SCREED RAIL SUPPORT
N.T.S.

CELL NAME = SCRSUP

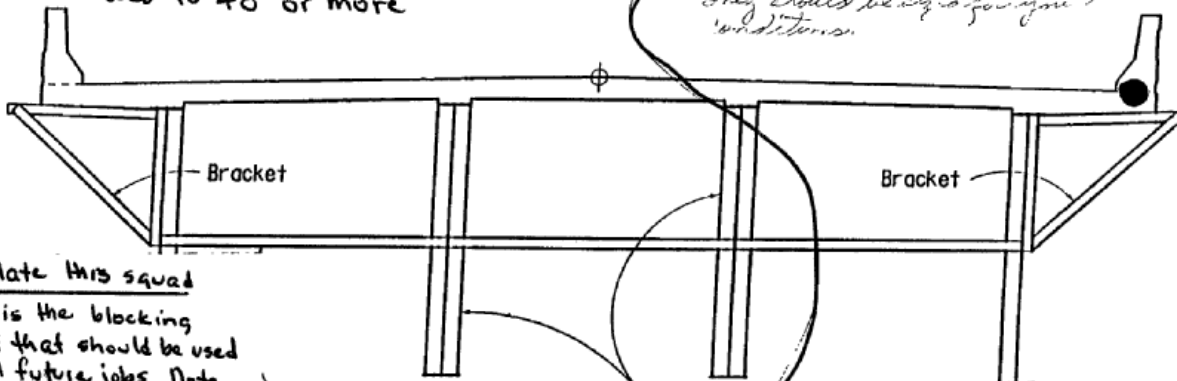
Use this detail when web is 48" or more

stiffener size to be adjusted for particular design
The size of the stiffeners shown design
are determined for a top girder...
They should be sized for your
conditions.

Circulate this squad
This is the blocking detail that should be used on all future jobs. Note the stiffener addition notes.
